**LOUISBURG PLANNING COMMISSION MEETING MINUTES**  
**Wednesday June 27, 2018**

**Item 6:** 18001-SP - 1150 West Amity, Casey's Convenience Store (Parcel ID: 1093003001006040)

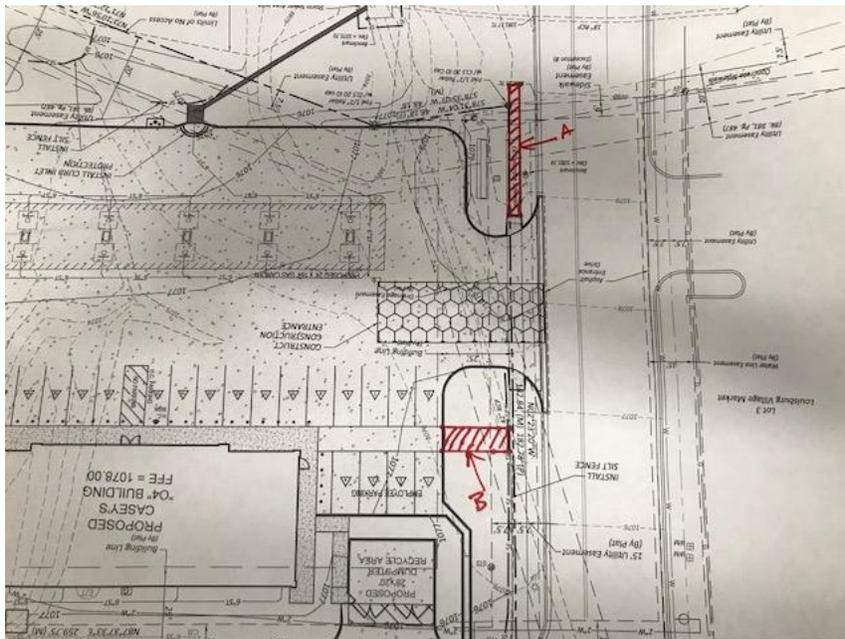
Sauber then expressed his concern for the need for a sidewalk on the south side of the proposed Casey's property. Sauber noticed that there is not a sidewalk on the site-plan and he feels that one should be installed. Sauber felt that his fellow commission members should examine the sidewalk requirement further. Law mentioned that the City has applied for a grant to install a sidewalk from Broadway to Crestview Drive which would be installed on the south side of Amity. Administrator Law explained the right-of-way between K68/Amity and the older part of the cemetery is insufficient to construct a sidewalk on the north side of the road. If the city were to place a sidewalk along the south side of Casey's property a cross walk would have to be installed at the corner of South Rogers Road and K68/Amity. That would involve placing a stop light at that location. Most

After additional discussion it was determined that a sidewalk on the south side of the Casey's property would be difficult to install due to the existing storm water retaining pond on the property. Nate Apple suggested if staff is able to have a sidewalk installed in the area please do so.

It also was suggested that Casey's extend the sidewalk along the private access road to lineup with the existing sidewalk located in front of O'Reilly Auto Parts Store (See below picture "A"). It was also recommended that the sidewalk near the front of the Casey's be extended when a crosswalk is installed at the intersection of Sutherland and K68/Amity (See below picture "B"). Jeff Laubach agreed to both sidewalk requests.

1. Enclosed 28' x 20' dumpster/recycle with brick **not** chain-link woven material.
2. Existing monument sign advertising businesses presently located in the Village Market Subdivision shall be split from the Casey's property so that the existing monument sign is located on a separate tract of land. Applicant shall submit a new site-plan and final plan indicating the requested property split.
3. A note shall be placed on the site-Plan stating that Storm Water Drainage has been sufficiently designed to accommodate the proposed building and paved area. In addition, a stamped letter from an engineer stating the same. A storm full water study is not needed as long as an engineer's stamped letter is submitted.
4. Sidewalks located on the west side of the property shall be extended as indicated in the above picture (items A and B).
